**STATE SIGNIFICANT DEVELOPMENT:
Section 96(1A) Modification Application**

***One Carrington Street (formerly known as
'City One'), Sydney***

SSD 5824 MOD1

Environmental Assessment Report
Section 96(1A) of the *Environmental Planning
and Assessment Act 1979*

Figure 5: the approved (top) and proposed (bottom) architectural façade composition and fin depth location (Base source: SSD 5824 and applicant's RtS)

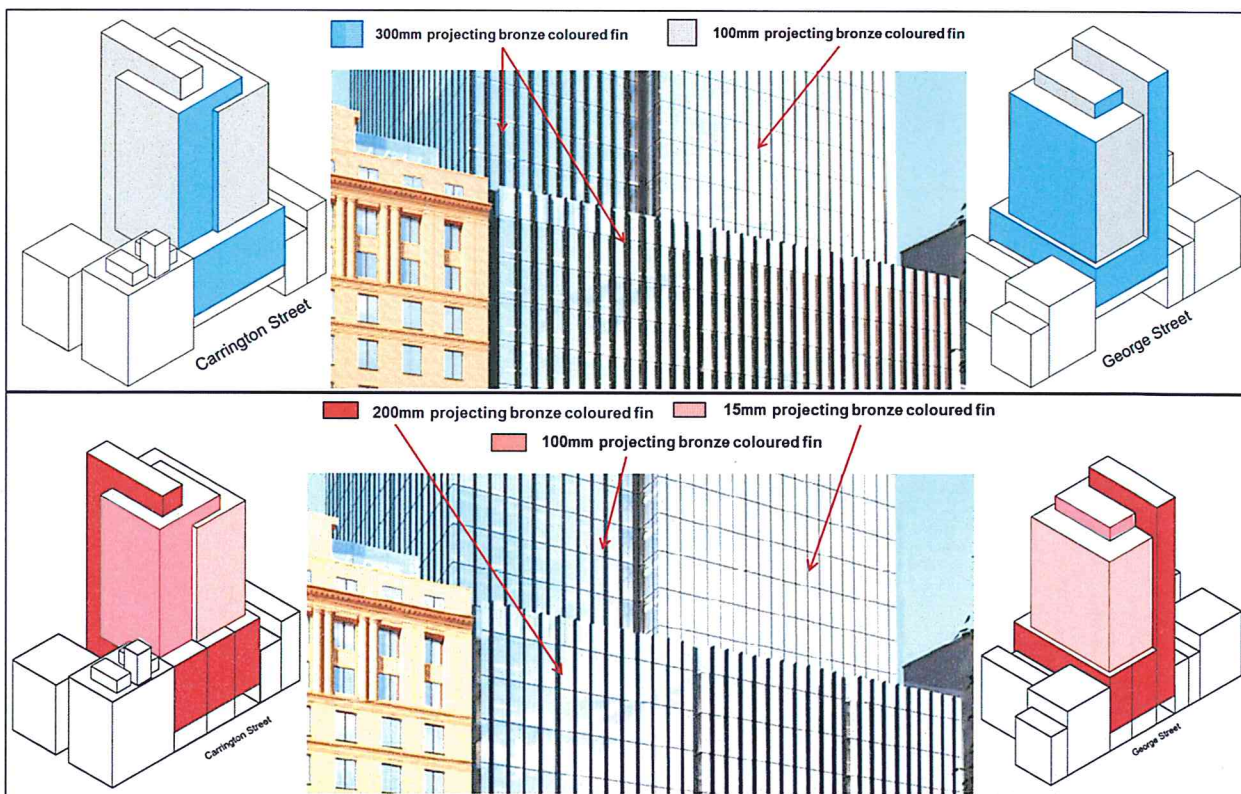
The Department requested further clarification of the amended tower façade composition and particularly justification for the reduction in the depth of the proposed projecting fins.

The proposal amends the tower façade composition by providing three (instead of two) vertical fin depths of 15mm, 100mm and 200mm (Figure 5).

The applicant asserts that the amendment will achieve greater contrast between the façade's interlocking segments. In addition, the contrast between the three façade types reinforces the

The Department considers that the proposed amendment in the façade treatment is acceptable as:

- the revised fin depths emphasise the three distinct interlocking built form components on both the George Street and Carrington Street facades and therefore strengthen the articulation of these elevations;
- the 15mm fin/capping provides a fine grain articulation to the facades, which integrates the overall materiality and architectural approach. The 15mm fin/cap also provides a visually lighter weight cladding, which adds additional visual interest to the overall appearance of the tower; and
- the reduced fin depth to the podium (300mm to 200mm) is minor in nature and would not be noticeable from a pedestrian perspective. The modification will maintain a suitable level of visual solidity to the podium elevations / base of the tower.

Figure 6: Public domain concept plan including treatment of Wynyard Lane (Base source: applicant's RtS)

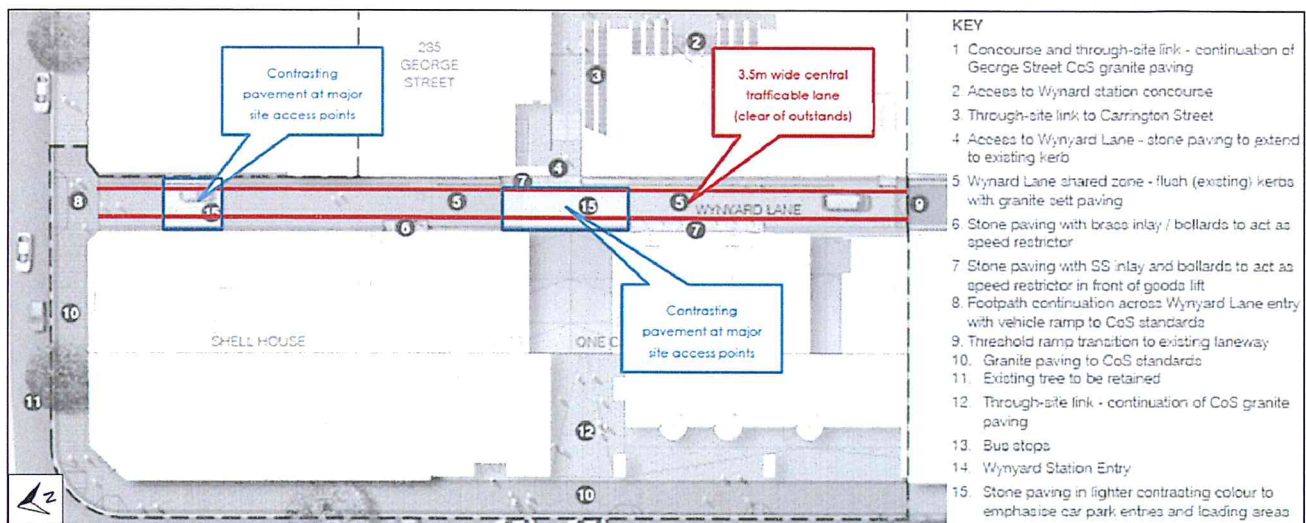
TfNSW raised initial concerns that:

- the public car park entrance from Wynyard Lane should include a pedestrian pathway to enable public access to the car park;
- the stone paving with brass inlay/bollards along Wynyard Lane would adversely impact pedestrian safety and restrict the turning path of vehicles into 275-281 George Street; and
- pedestrians entering Wynyard Lane opposite the car park entrance are likely to conflict with vehicles entering the car park.

TfNSW also recommended a condition requiring a road safety audit for the Wynyard Lane works and requested that it be consulted during the design of the Wynyard Lane shared zone.

The applicant responded to TfNSW's concerns, asserting that a pedestrian path to the public car park is not required as access will remain via the existing public entry and ticketing point located at the Coles supermarket level within Wynyard Station. Furthermore, a road safety audit will be provided at the time of preparing the shared zone. In response to remaining concerns the applicant has agreed to TfNSW's recommended conditions and has also amended the proposal (refer to **Figure 6**) to:

- remove the brass inlay/bollard area south of Margaret Street to address the restricted vehicle turning path into 275-281 George Street;
- provide a central trafficable lane, which will reduce potential conflicts between pedestrians and vehicles; and
- provide an extended pedestrian area opposite the main vehicle entrance and provide contrasting paving to car park entries and loading areas.

The Department notes that condition B14 requires the applicant to consult with TfNSW on the design of the proposed shared zone. Furthermore, the amendments to the scheme noted above satisfactorily address the majority of TfNSW's concerns.

The Department accepts that a dedicated pedestrian path to the public car park is not required from Wynyard Lane as the principal access to the car park is via the existing public entry and ticketing hall within Wynyard Station. The Department also agrees with TfNSW that the application should provide a road safety audit at the appropriate time and comply with the fire and life safety requirements of the BCA, and conditions are attached accordingly.
